TO: Borough of Fair Haven Zoning Board of Adjustment

FROM: Elena Gable, PP, AICP, CFM

RE: James Cady
137 Grange Avenue
Block 22 Lot 53
Completeness & Bulk Variances v3

DATE: June 15, 2021

Photo of existing secondary driveway curb cut and dwelling

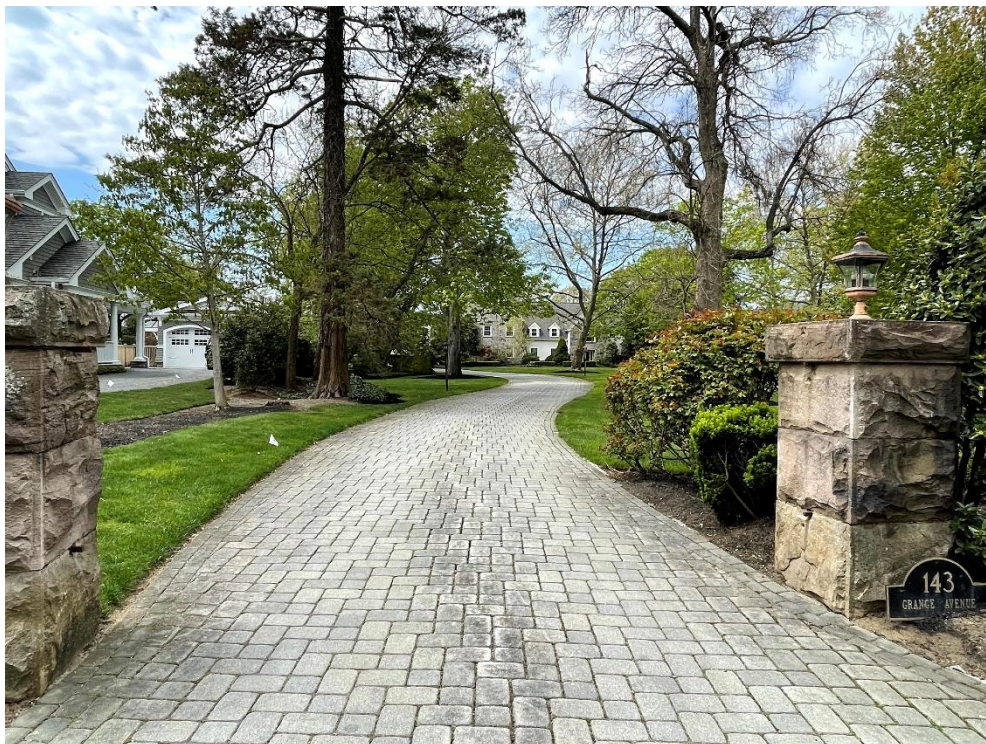
- a. We note the applicant had previously applied to the Zoning Board in 2019 and had subsequently withdrawn their application. At the time of their last application, the property had two existing curb cuts and the horseshoe shaped driveway. A site visit indicates that the 2nd curb cut for the driveway remains and that the horseshoe shaped driveway has since been removed and revegetated.
